CAFO WPDES Compliance Report (10-30-09)

Inspection type: Permit reissuance

Operation Name: Dairyland Farms LLC

WPDES Permit No. WI-0059552-02-0

Looking south at earthen manure storage.

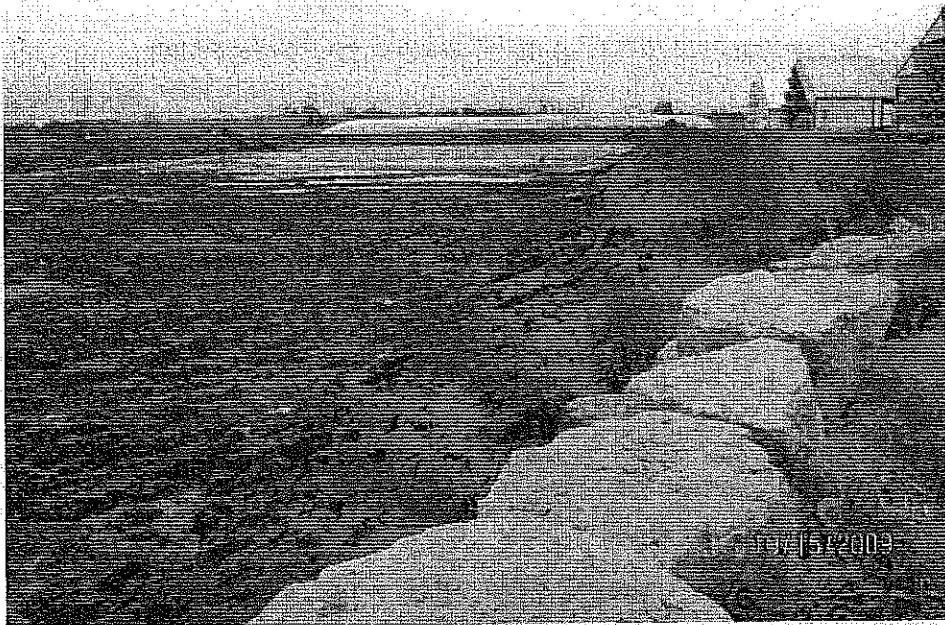
The Dairy Center facility is well maintained—surrounding drainage ditches are mowed and wheat straw bedding is kept in silage bags. Manure levels were below margin of safety and storage appears to be in good condition. Dufek indicated that Dan Davister is in charge of weekly inspections of the storage which are recorded in the CAFO Calendar. Davister indicated he walks the perimeter of the storage and has repaired rodent holes by filling with a combination of gravel and dirt. Manure storage does not have fencing in place—fencing a minimum of 4 feet high needs to be installed.

Close-up of tank collection.

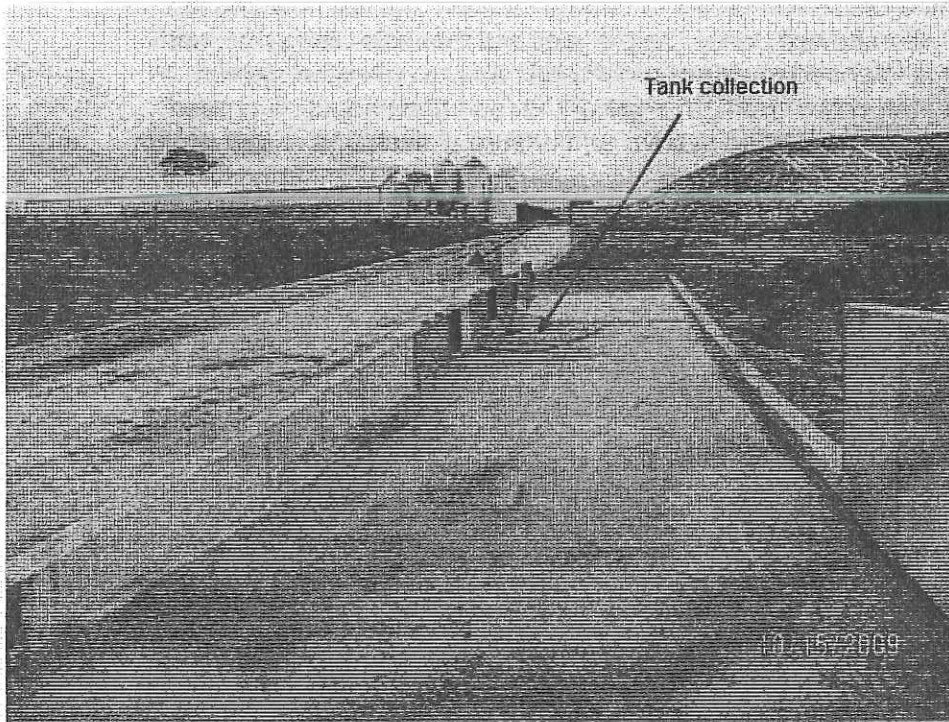
Weekly inspection of the feed storage area runoff system will be required in reissued permit. Tile inlets and manhole need to be cleared of solids to prevent clogging.

Jones told Dufek a set of as-built drawings to show complete construction documentation of the feed leachate collection system that includes a map of drain tile system will need to be submitted after completion of project. Dufek stated that installing a secondary settling basin within the VTA area is an option if the VTA does not support the volume of storm water runoff.

Looking east at recently constructed runoff controls for feed storage area. VTA will be to south.

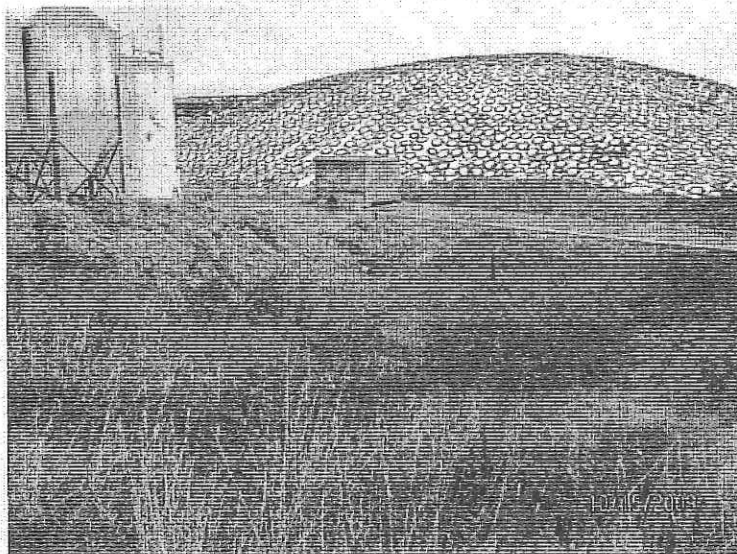
Above: Looking southeast, ditch in foreground will be filled in to divert all runoff to concrete collection system.
